SUBJECT: RE DIMENSION of Quill & nose-piece

Housing nose-piece

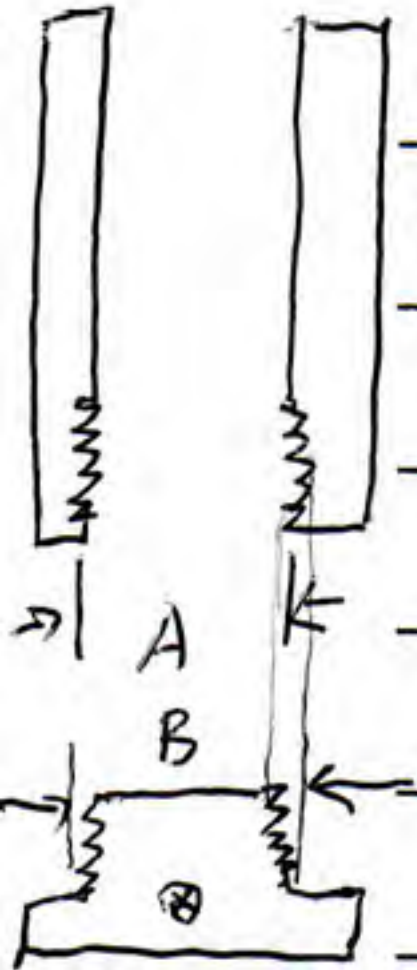
before MAY/2010	OLD : A : 73 mm	B : 74 mm
after MAY/2010 →	NEW A : 74 mm	B : 75 mm

INSIDE DIA of HOUSING

— OUTSIDE ϕ DIA. nose piece

Guy: please DOUBLE CHECK. ~~THIS~~ SPINDLE you received SHOULD BE 75 mm (B)

~~PL~~ ϕ & TRY TO MATCH A = 75 mm
